Technical Bulletin for Qbicle Fenders

Subject: Safety Notice on fender installations.

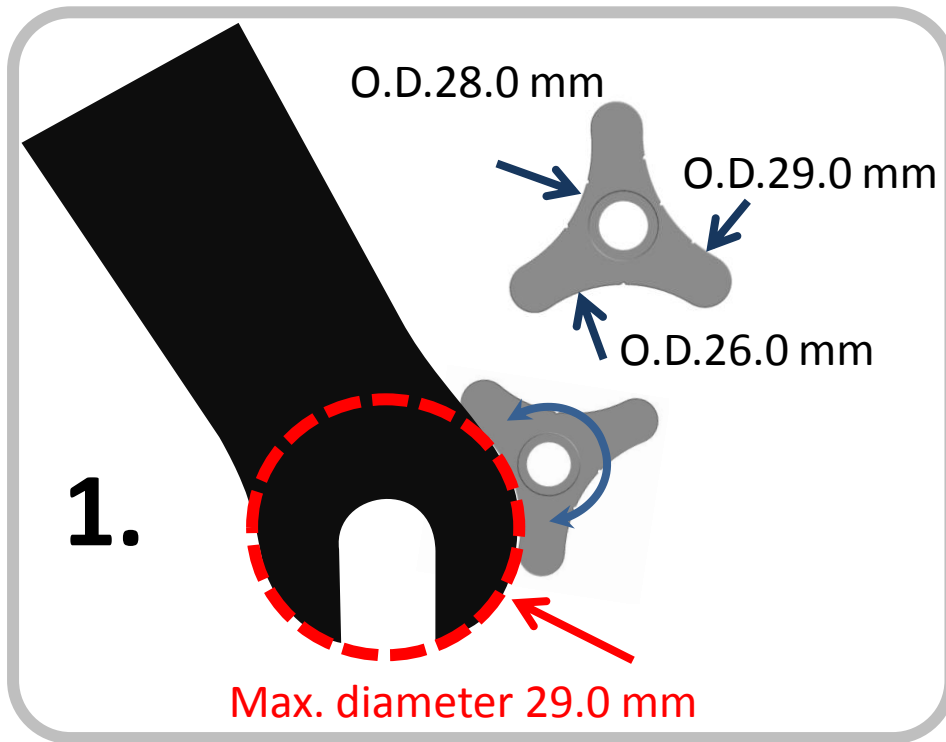
Qbicle fenders fit most of bike frame dropouts, however, under rare conditions of fender bracket being installed to dropouts, it is possible not to fit due to sizing factors. Please make sure the complete check as follows before consumers install to avoid any crash hazard or fall damage.

- Check notices 1-2-3 for front wheel.
- Check notice 3 for rear wheel.
